AMENDMENTS TO THE DRAWINGS

REMARKS

Benjamin et al.
Serial No. 10/697,695

Fig.1

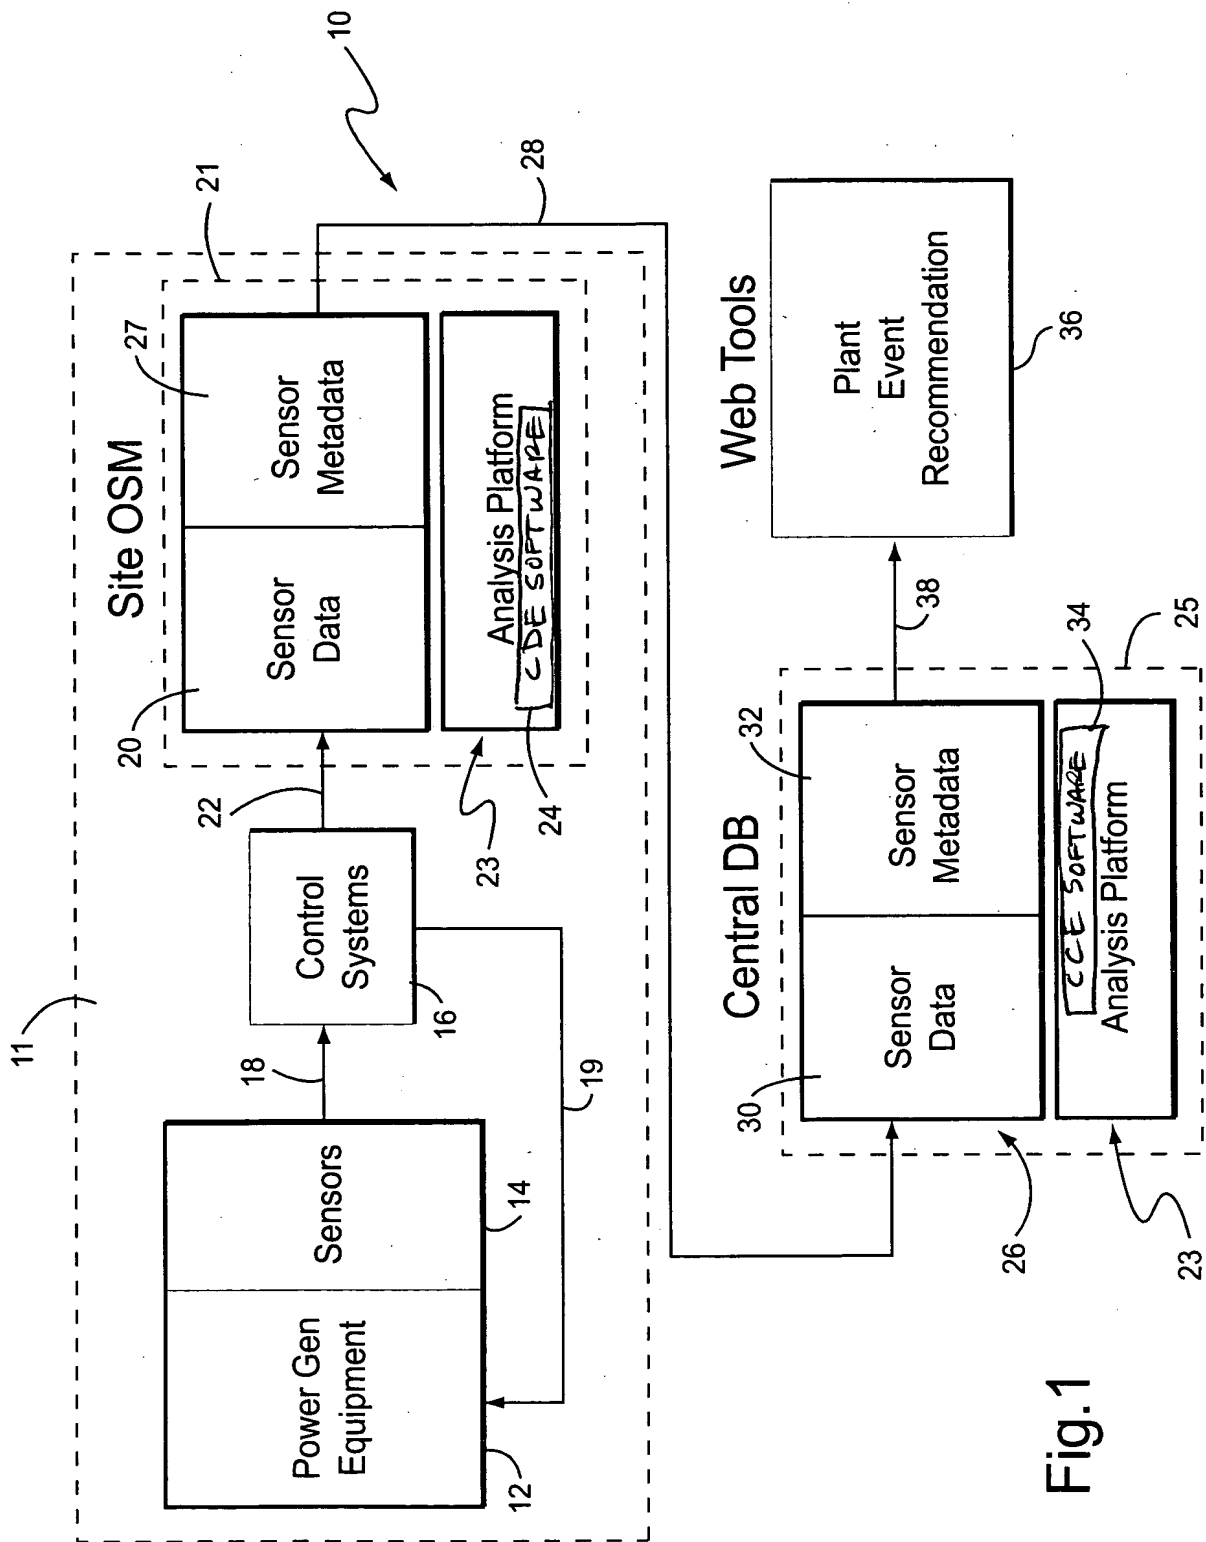
In the outstanding Office Action of February 11, 2005, the Examiner objected to the drawings and suggested that Figure 1 be amended so that reference numeral "24" and "34" identify a component inside the "Analysis Platform" illustrating the "CDE Software" and the "CCE Software", respectively. The amendment to Figure 1 proposed by the Examiner has now been made. Accordingly, the Examiner's objection to the drawings should be withdrawn.

The attached sheet of drawings includes changes to Fig. 1. This sheet replaces the original sheet including Fig. 1. In Fig. 1, the portion of analysis platform 23 in on-site monitor 21 has been amended to specifically show the CDE software 24, and the portion of analysis platform 23 in central management system 25 has been amended to specifically show CCE software 34.

A marked-up copy of Fig. 1 is also being submitted herewith.
